Edge Grove School, Aldenham, Hertfordshire

Former stable block: Addendum to the Heritage Statement

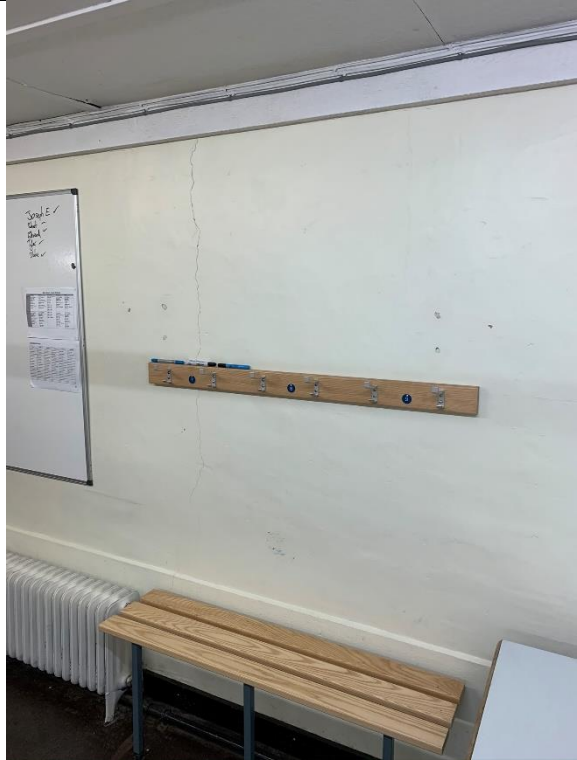
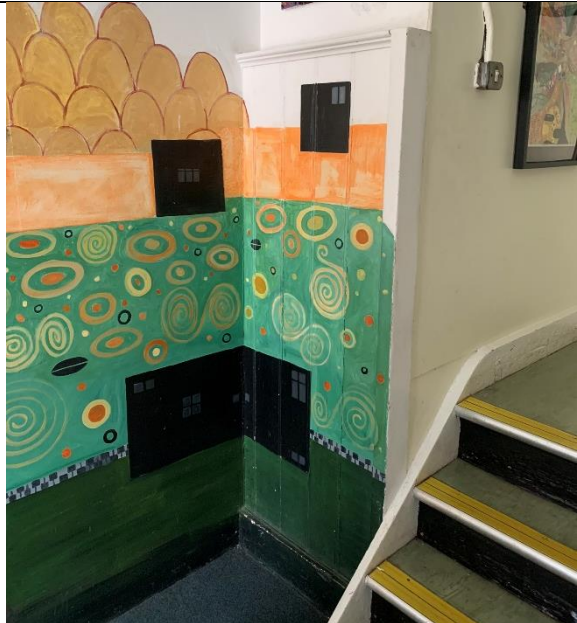
Item	Query	Response
Ground floor		
1	Proposed new door opening: <i>What age/value is this fabric? Was there a previous opening here to inform location of new opening?</i>	<p>The seemingly blank walls to the rear of the old stable block are original to it, and thus of 18th-century date. There is clear evidence of a former opening in this location, comprising vertical cracks in the rendered and painted wall face (now within the changing room) running down to floor level. Tap testing confirms that there is an audible change from the solid masonry to the sides with a 'hollowness' in the area between the cracks. The blank masonry is of limited significance/value despite its age (it is to the rear of the building, away from visibility from the house. The evidence for a former opening provides a good context for establishing the new one here, which will aid the utility of the original building as it relates to the proposed extension.</p>
